# GRADING AND EROSION CONTROL PLANS FOR WALDEN SANITATION DISTRICT WASTEWATER TREATMENT PLANT PROJECT EL PASO COUNTY, COLORADO MARCH 2026

EPC DPW Stormwater did not fully review the last GEC submission since it was not associated with a stormwater permit. New information provided with this submission has triggered the requirement for an ESQCP, so full comments will be provided at this time. See comment on sheet 12 for additional information.

SHEET TITLE:		
EROSION CONTROL PLAN II		
PROJECT NUMBER:	SCALE:	SHEET:
#3774	1"=40'	C7.2

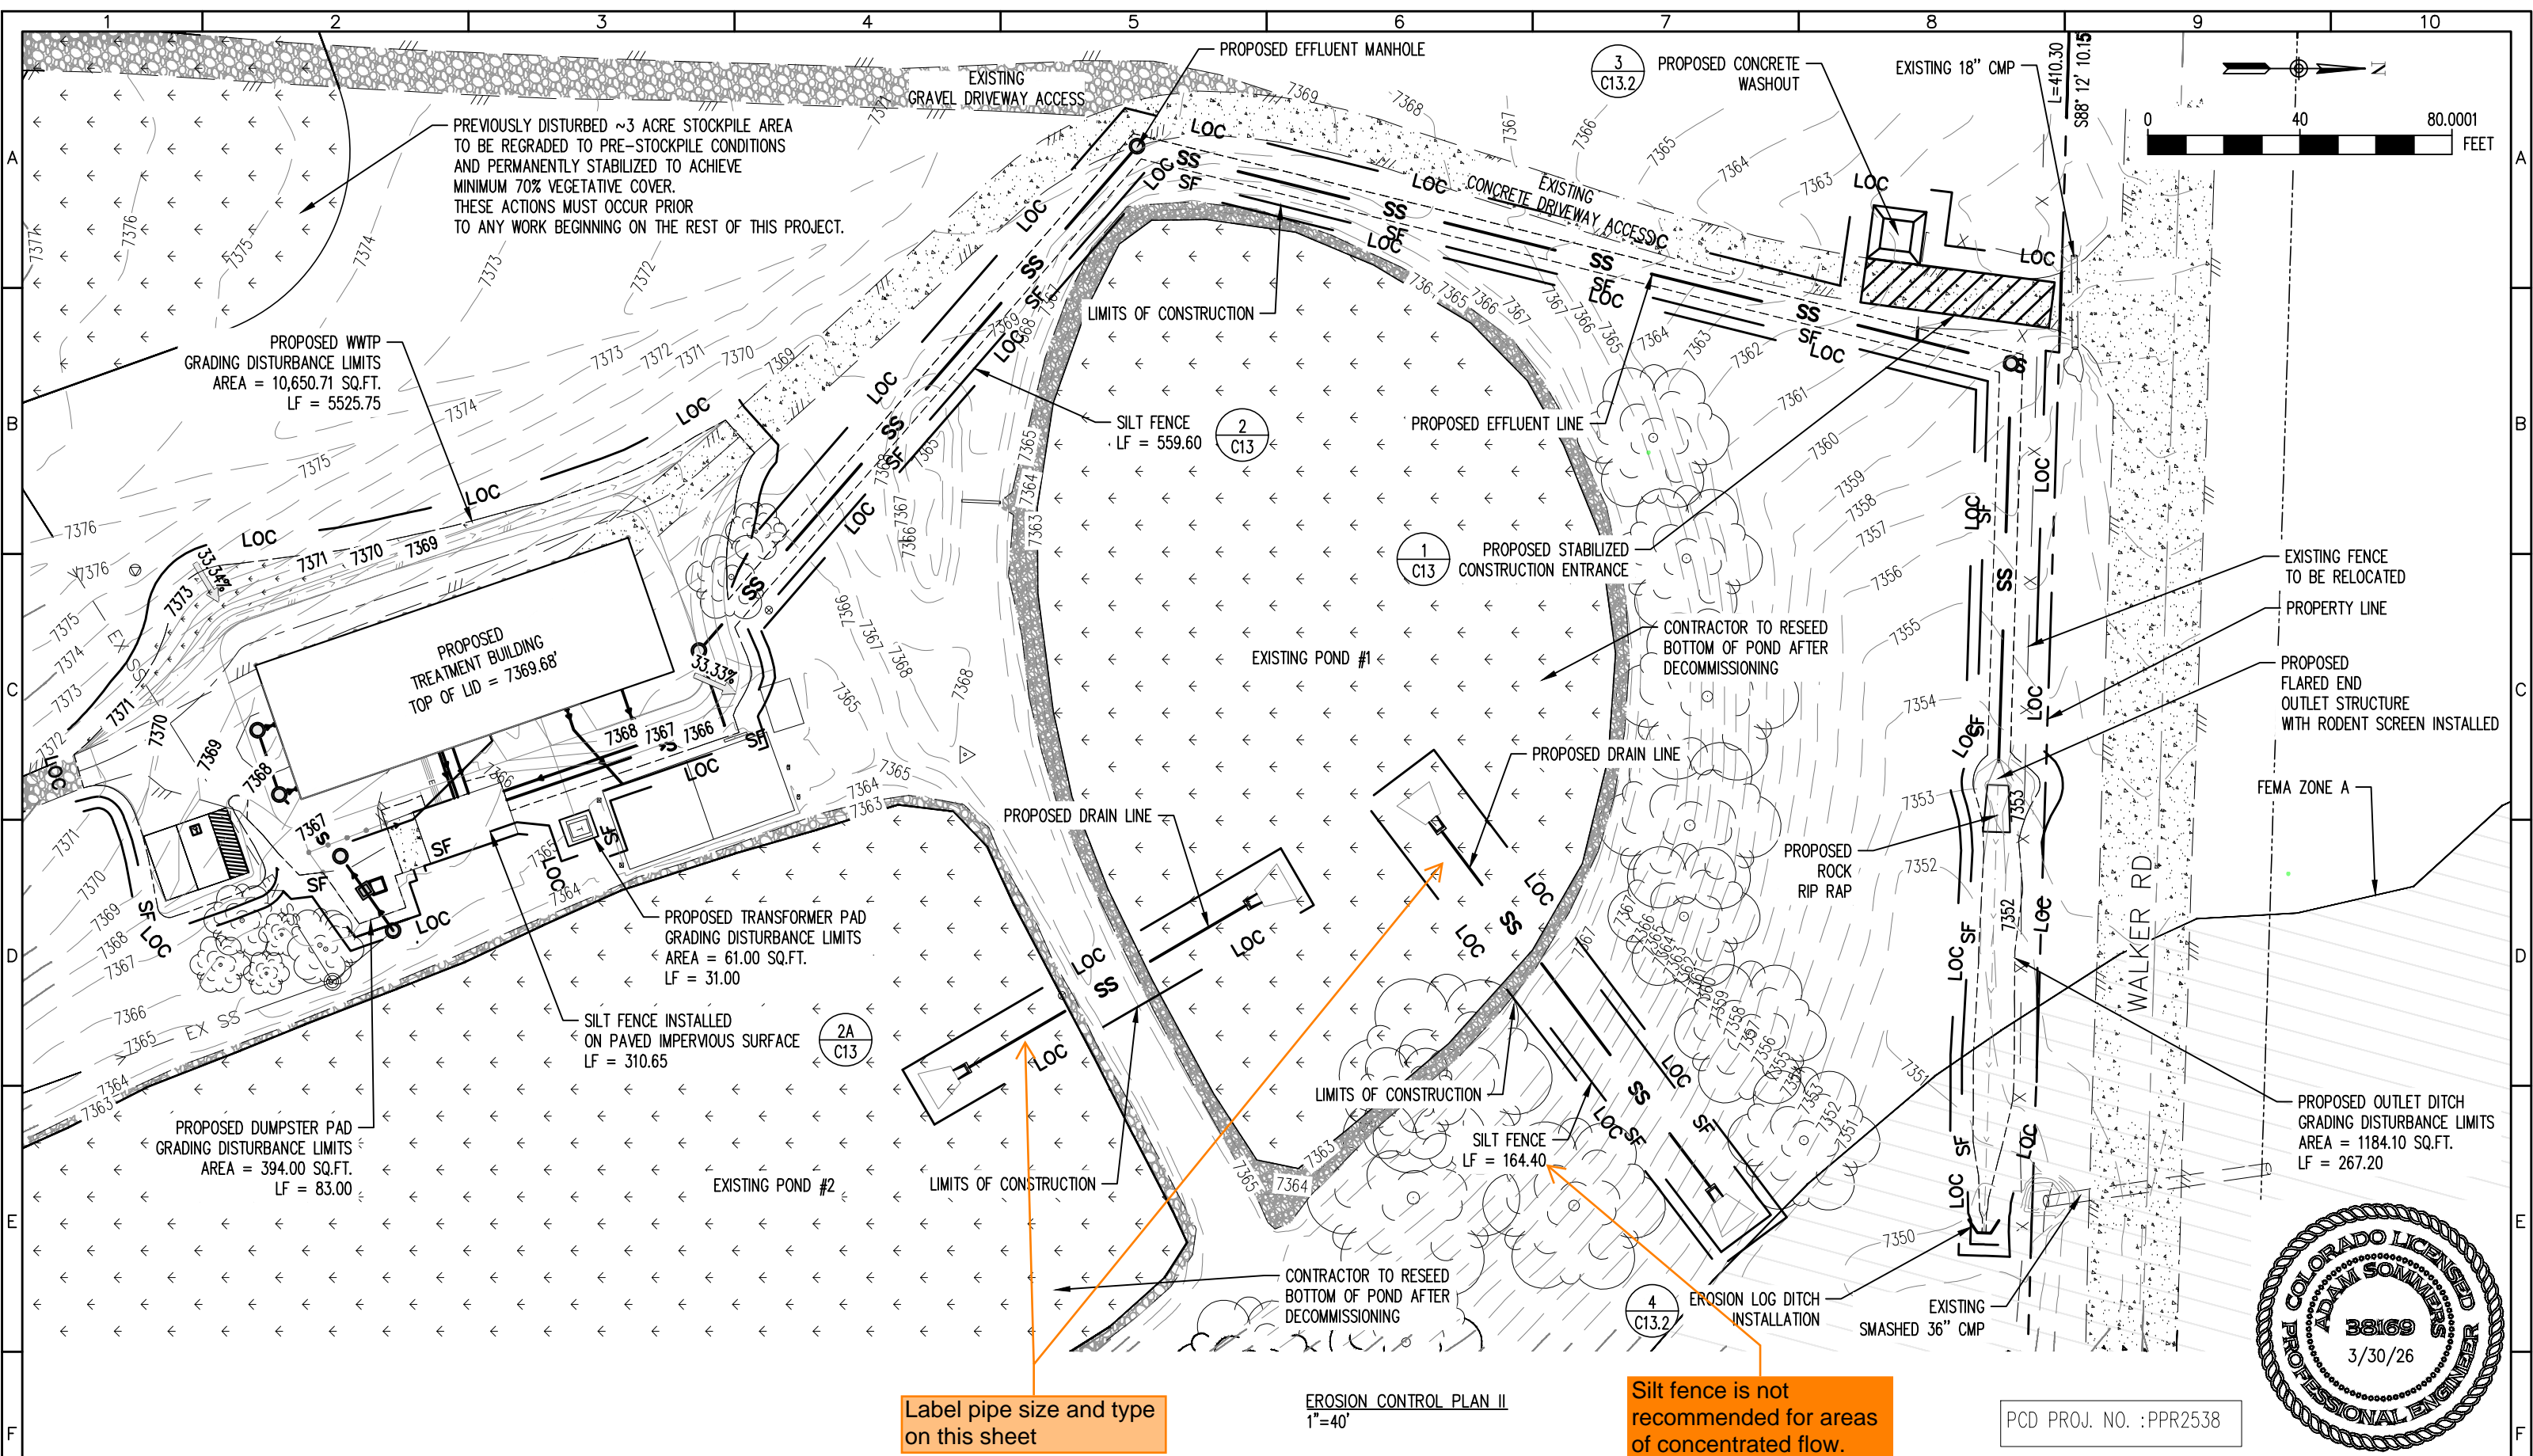
Label pipe size and type on this sheet

SHEET TITLE:  
 LAGOONS CLOSURE PLAN  
 PROJECT NUMBER: #3774  
 SCALE: 1"=100'  
 SHEET: C11

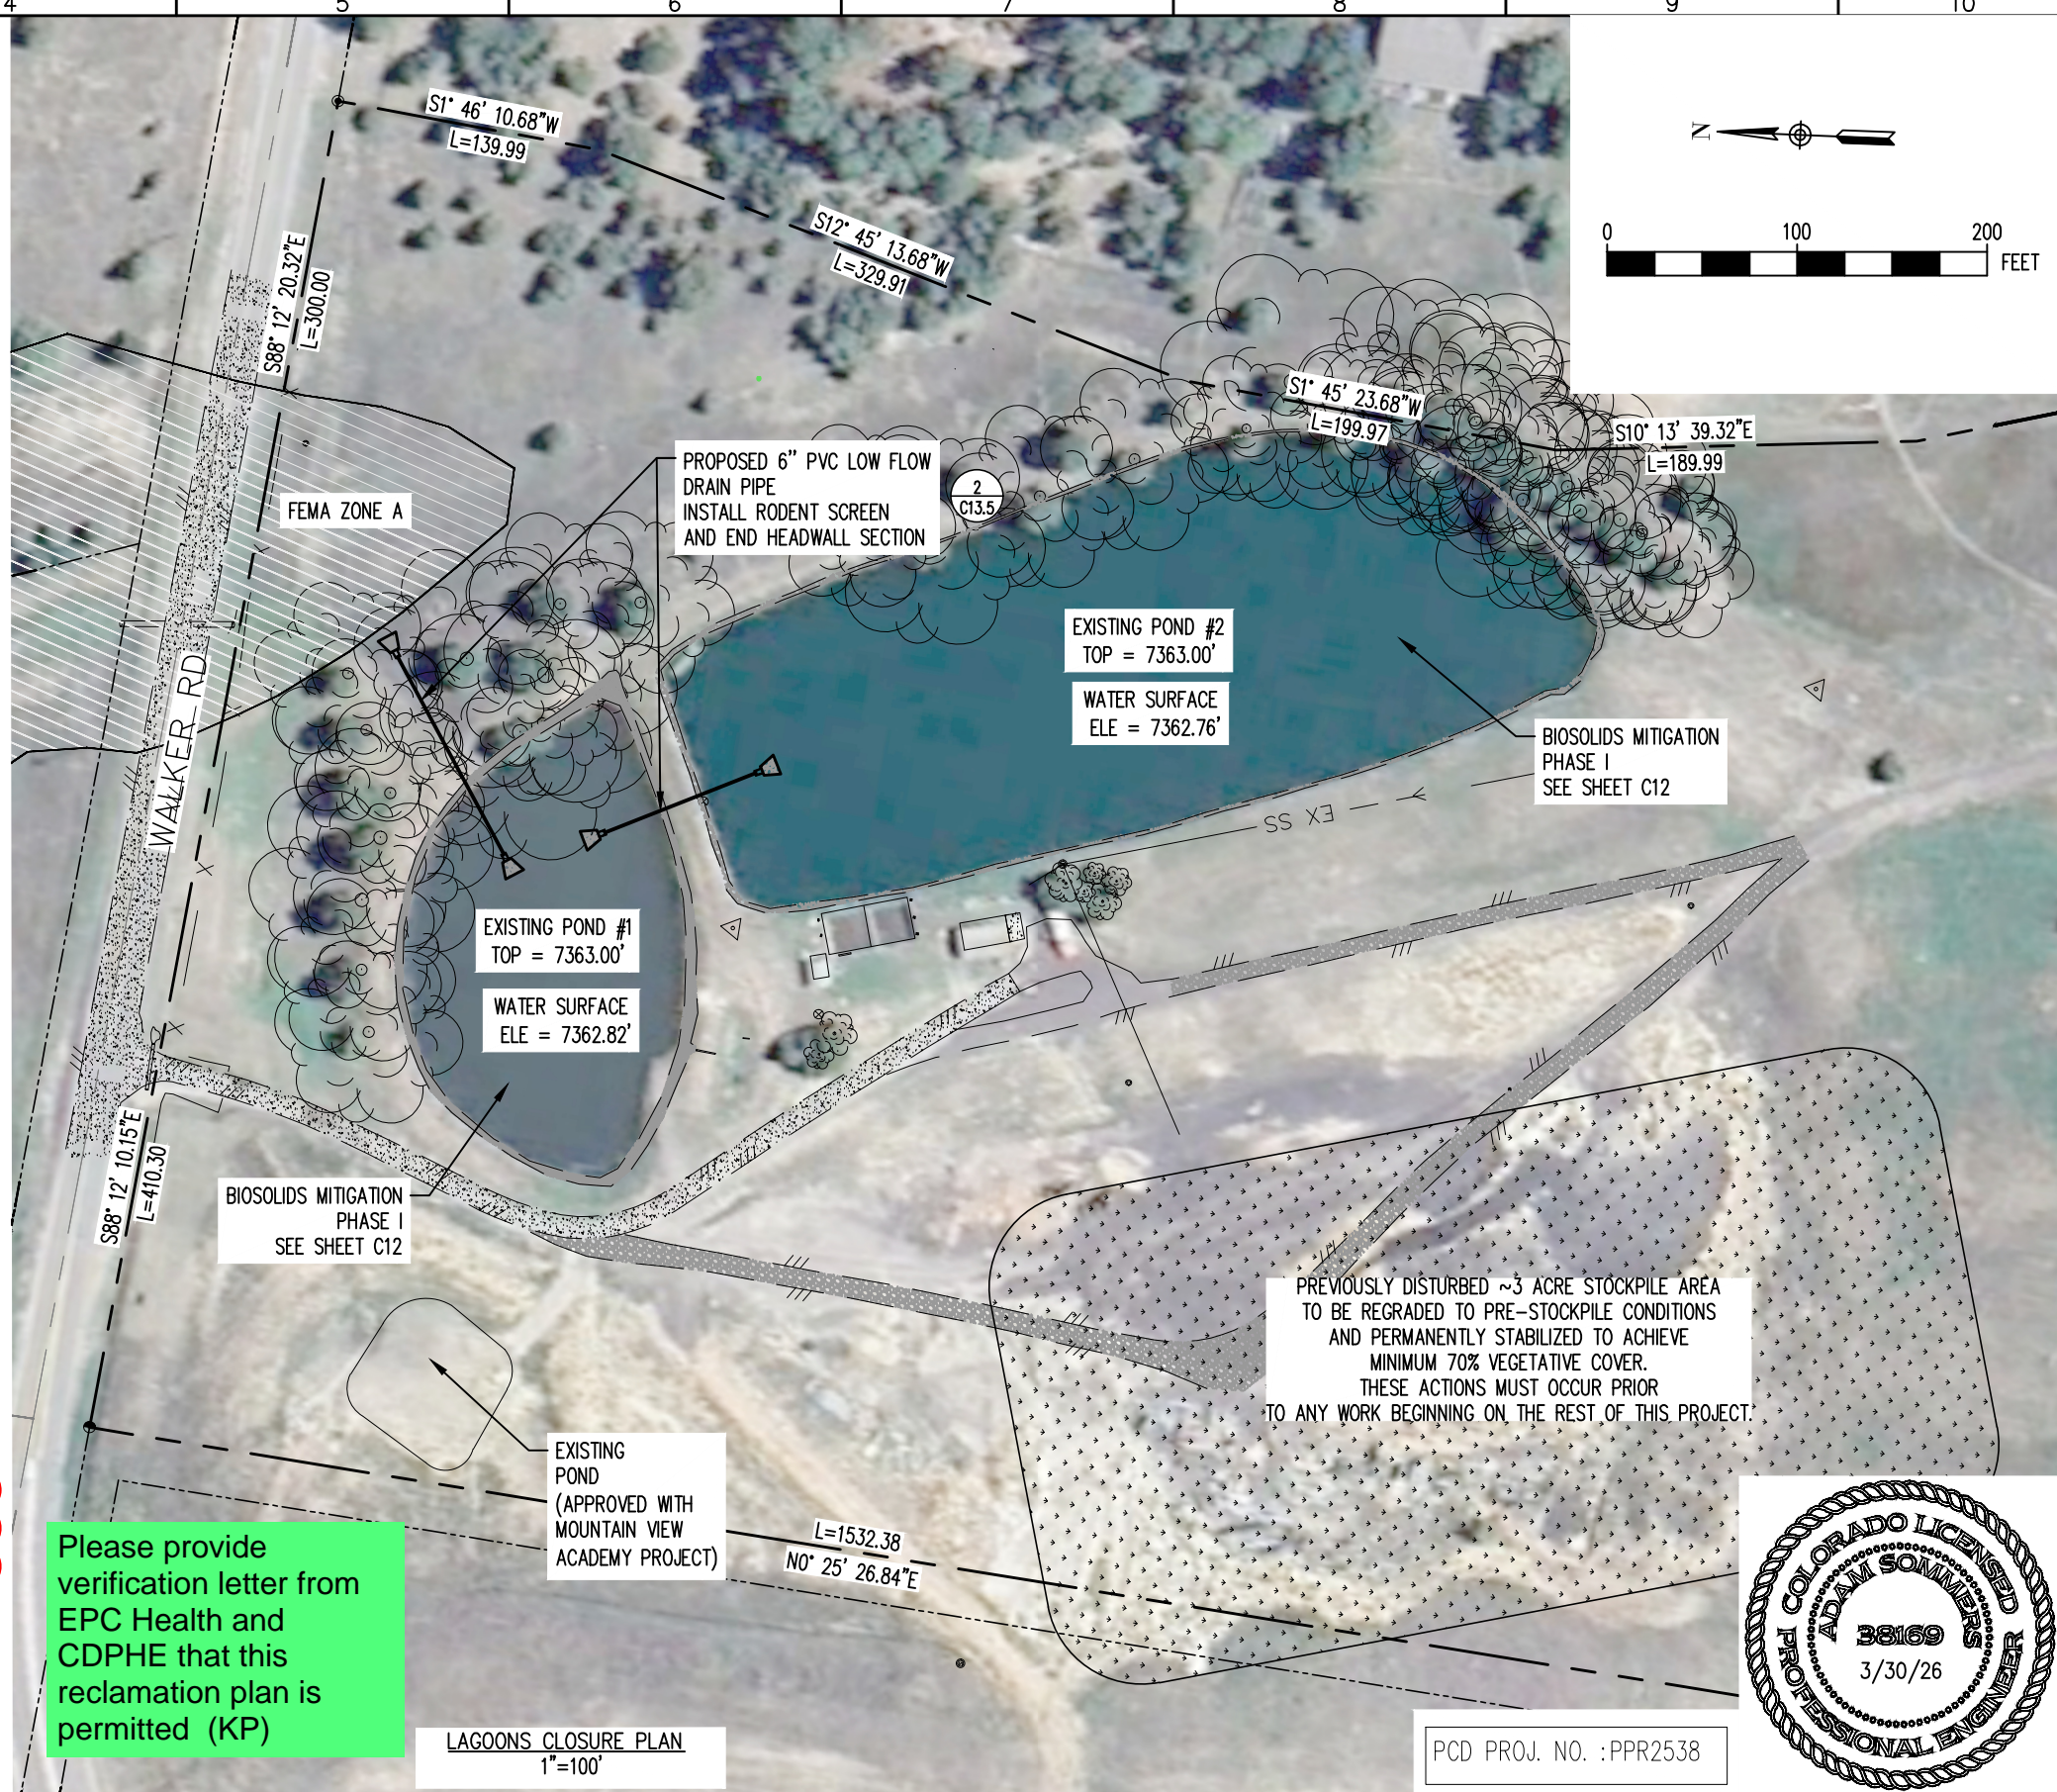
Can this information be added to the Pond Reclamation plan document

Show stockpile area on GEC plan

Clarify when drain pipes will be installed

Please provide verification letter from EPC Health and CDPHE that this reclamation plan is permitted (KP)

SHEET TITLE: EROSION CONTROL DETAILS I		
PROJECT NUMBER: #3774	SCALE: N.T.S.	SHEET: C13

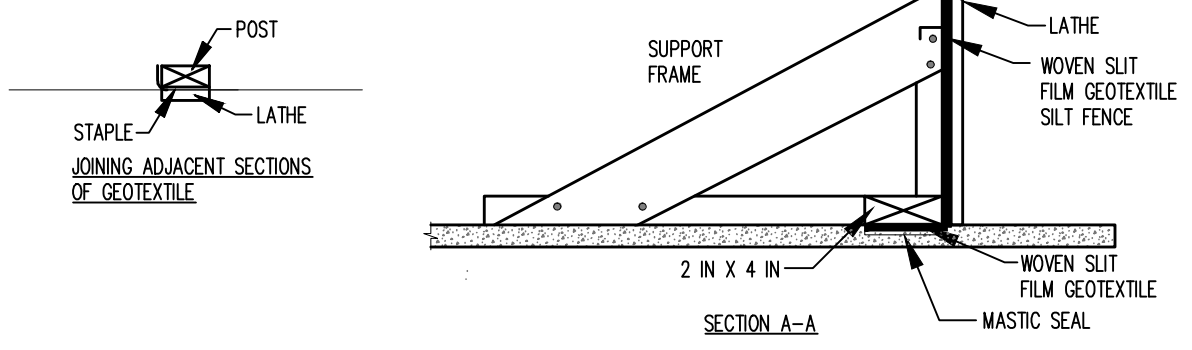
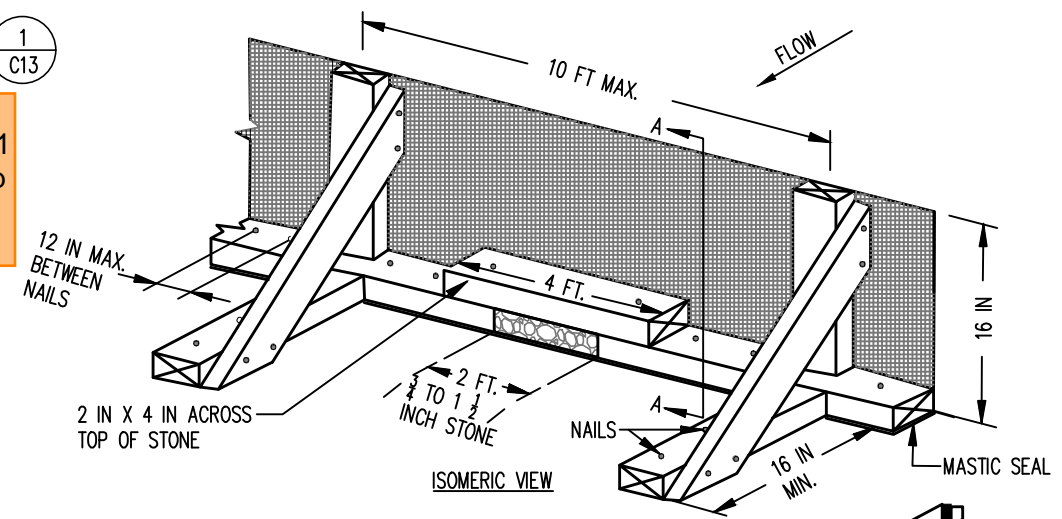
Replace with EPC approved VTC detail (VT-1 and VT-2 in DCMv2, Chap 3.3) or revise to be 75ft min length.
